Access Compliance Report Public Rights-of-Way (Curb Ramps)

Main Street: N_SELLAS_RD Cross Street: SOLSTICE_DR Location: N

ADA ID: RPAT211101104607 Ramp Type: Type 4 - Parallel Initial Pass/Fail: Fail Overall Compliance: No Severity Score: 30

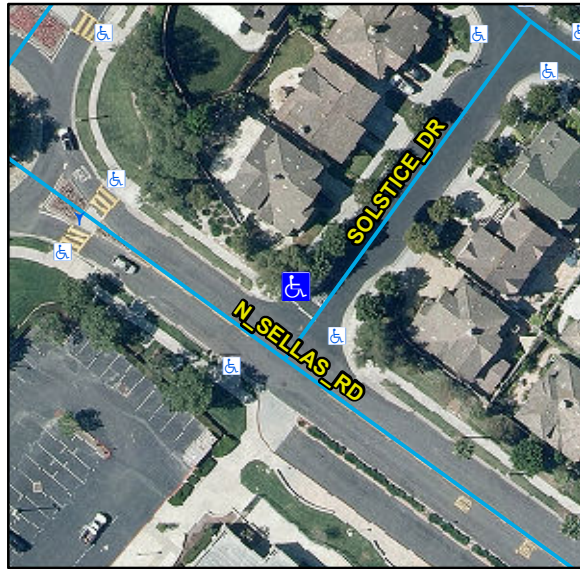
Compliance	Description	Data	Compliance	Description	Data
N/A	Ramp Length LT (in)	95	N/A	Ramp Length RT (in)	87
Yes	Ramp Width LT (in)	86	Yes	Ramp Width RT (in)	89
Yes	Ramp Run Slope LT (%)	3.3	No	Ramp Run Slope RT (%)	12.2
Yes	Ramp Cross Slope LT (%)	1	Yes	Ramp Cross Slope RT (%)	1.6
N/A	Landing Present	N/A	N/A	DWS Provided	N/A
N/A	Landing Length (in)	N/A	N/A	DWS Contrast	N/A
N/A	Landing Width (in)	N/A	N/A	DWS Length (in)	N/A
N/A	Landing Run Slope (%)	N/A	N/A	DWS Full Width	N/A
N/A	Landing Cross Slope (%)	N/A		DWS Offset Type	N/A
N/A	Landing Movement Obstructed?	N/A	N/A	DWS Offset Left (in)	N/A
	Landing Movement Type	N/A	N/A	DWS Offset Right (in)	N/A
N/A	Landing Shared	N/A			
N/A	Clear Space	Yes			
N/A	Clear Space To Crosswalk (in)	N/A			
N/A	Marked Crosswalk 1	No	N/A	Marked Crosswalk 2	No
	Crossing 1 Direction	SW		Crossing 2 Direction	SE
	Marked Crosswalk 1 Width (in)	N/A		Marked Crosswalk 2 Width (in)	N/A

Remove & Replace Curb Ramp With Two New Directional Ramps or Equivalent.
